Fw: CC Agenda 2/23/21 10.2 Amendment to the San José Citywide Design Standards and Guidelines. - Do Not Apply to **Evergreen's Extremely Large Sites**

RE: Questions and Comments on Proposed Citywide Design Standards and Guidelines Final Draft

Item 10.2 Design Standards and Guidelines

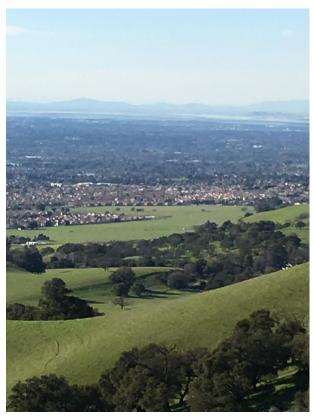
Evergreen Industrial Campus - 368 acres (photo below Measure B site in center) Evergreen Valley College - 27 acres of Neighborhood Community Commercial General Plan Designation Pleasant Hills Golf Course - 114 acres Eastridge - 103 acres Reid Hillview Airport - 180 acres

The Pleasant Hills Golf Course could develop in residential uses considerably more quickly than Eastridge and Reid Hillview.
